**Application for a site compatibility certificate - SCC\_2019\_TWEED\_001\_00**

With reference to your letter dated 23/7/2019 seeking comment on the site compatibility certificate for Nos. Lot 18 DP 627632 No. 27 and Lot 22 DP 1170438 No. 49 Elouera Terrace, Bray Park the following is provided:

**Figure 1**

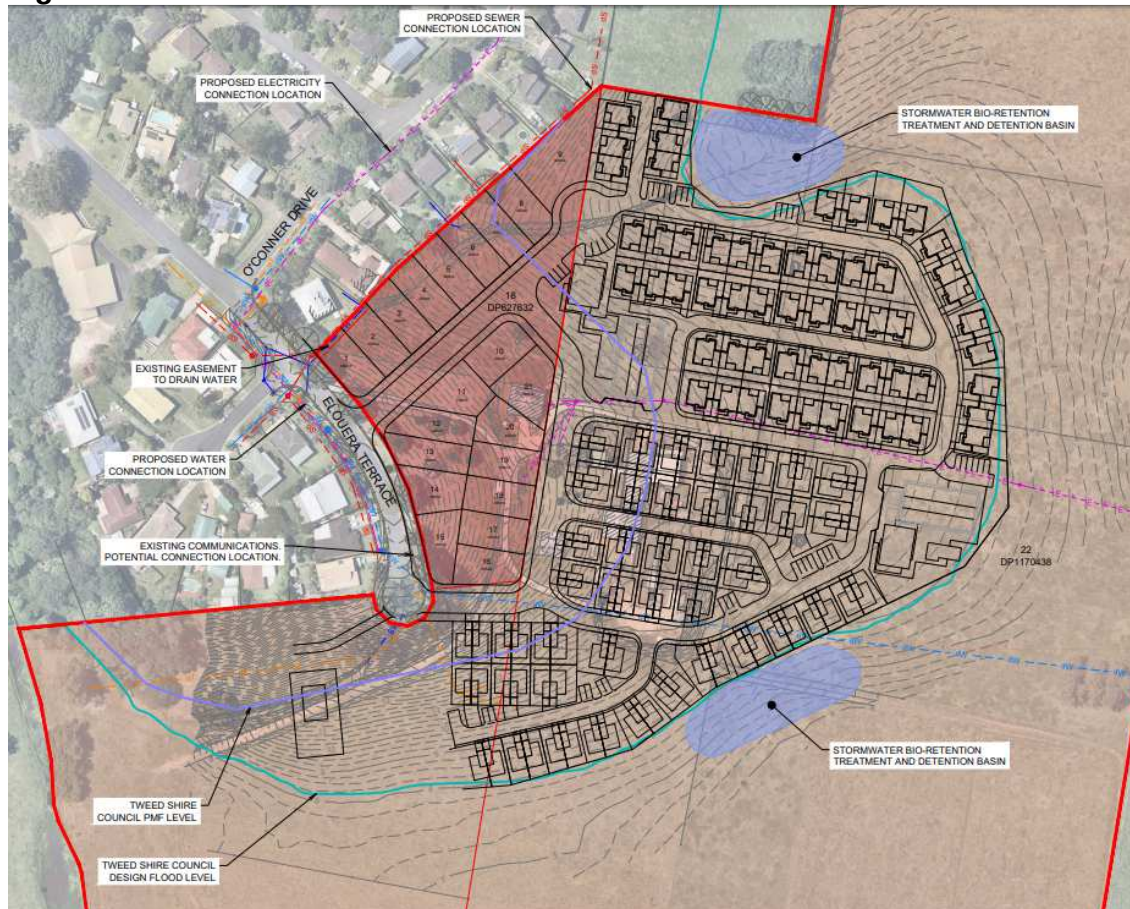
- a) The site plans (see Figure 1 below) show future residential subdivision on the R2 zoned portion of the land. This area is also the majority of the flood free land on the site, being above the PMF. A more appropriate process would be for the applicant to reconfigure their development proposal, to centralise the more sensitive, higher density land use (being aged housing) on the flood free portion, and then seek a planning proposal for the remaining land above the 1% AEP for other residential uses. Instead, the site design has been driven by the zoning boundaries and the use of the Seniors Housing SEPP in the RU1 zone, without due consideration of flood risk. Please note these comments are not to taken to assume any endorsement of a planning proposal.

**Figure 21 – Site Opportunities and SCC Footprint**

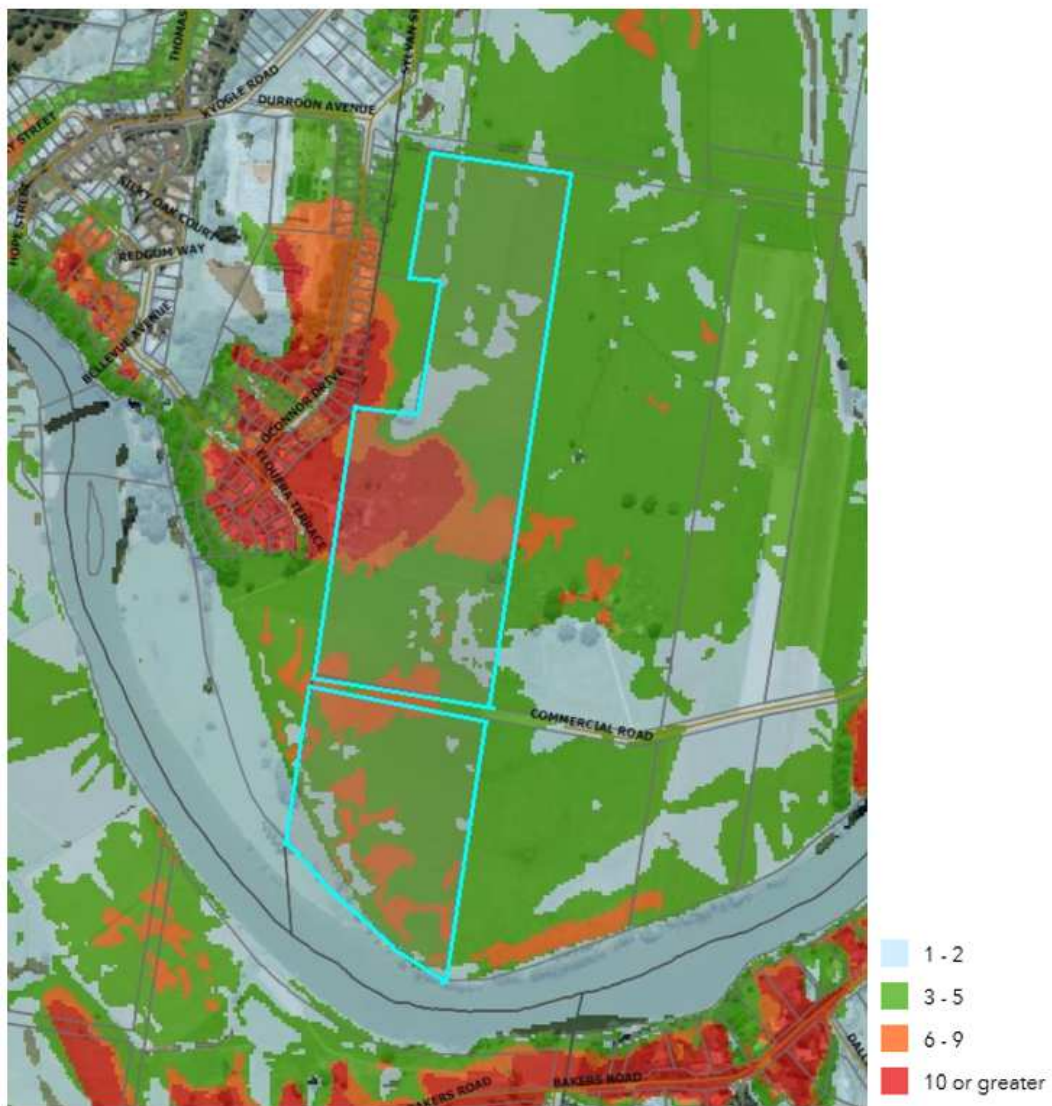
The indicative development footprint is presented in the application documents as Figure 21, shown below. This footprint correlates almost exactly with the most visible portion of the site as mapped by the Scenic Landscape Strategy Visibility Map (Figure 2).
